Subject: RE: DSA 2020/1597 Attn: Anne-Marie Young

Please accept the following submission with respect to DA2020/1597.

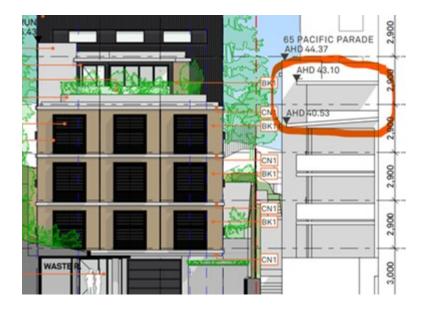
Level 3 Communal Outdoor Space- As the proposal stands, we have extremely strong concerns regarding the Level 3 Communal Outdoor Space. The COS is only 8 metres away, 1.5m above and directly opposite our balcony and living areas. This perspective view on the application (shown below) is the best visual representation of the relationship between the two spaces. We note that even this perspective shows no windows and under-assumes the length of our balcony. Our balcony extends across the entire building for approximately 10m and apart from the first 1.2m closest to the lift well, the entire north facing perimeter of our apartment is floor to ceiling glass into our living area.

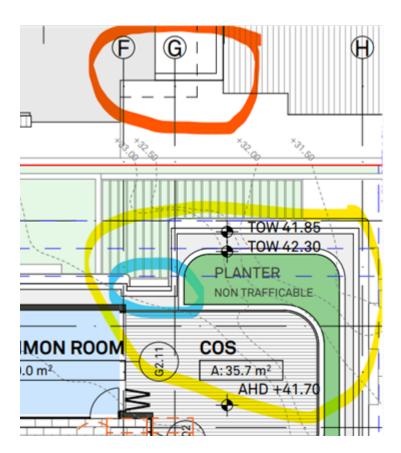
The Nth Elevation plan above poorly represents our balcony (area highlighted in red) again omitting the fact that, except for the first 1.2m, the northern face is all glass. Again, the drawing shows only to the centre ridge line of the pitched roof below our balcony balustrade. These omissions do give a false impression of the extent to which our privacy will be compromised as a result of a rooftop Communal Space next door. We believe the plan omissions could also explain the lack of consideration in subsequent specialist reports and council response to pre-assessment meeting..

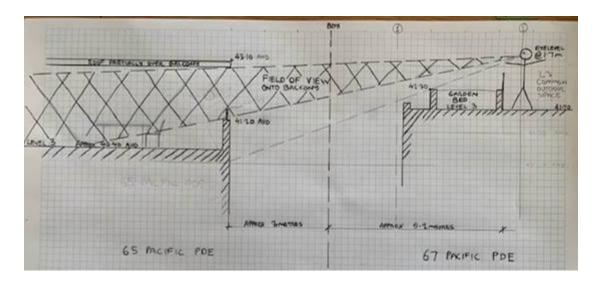
The level 3 plan above shows how the proposed COS is directly opposite and forward of (looking into) our balcony, as well as how the planter beds only partially along the western edge of the COS, neither of which give us any hope of privacy or noise mitigation.

I have drawn a to-scale drawing showing the direct line of sight available to those on the L3 COS, looking down onto our balcony.

It is unacceptable that our privacy from 18 (or more) people communing every night relies on a mere planter bed. Once built, we will have no control over the upkeep and effectiveness of this visual barrier. We would demand a proper built solution that obscures all direct viewing onto our balcony

- 1. planter beds extend the entire length of the COS on the western side **and**
- 2. the top of the outer wall of the planter bed or another **built** screen is increased in height sufficient to eliminate a direct line of sight down onto our balcony (suggest to 43.30 AHD)
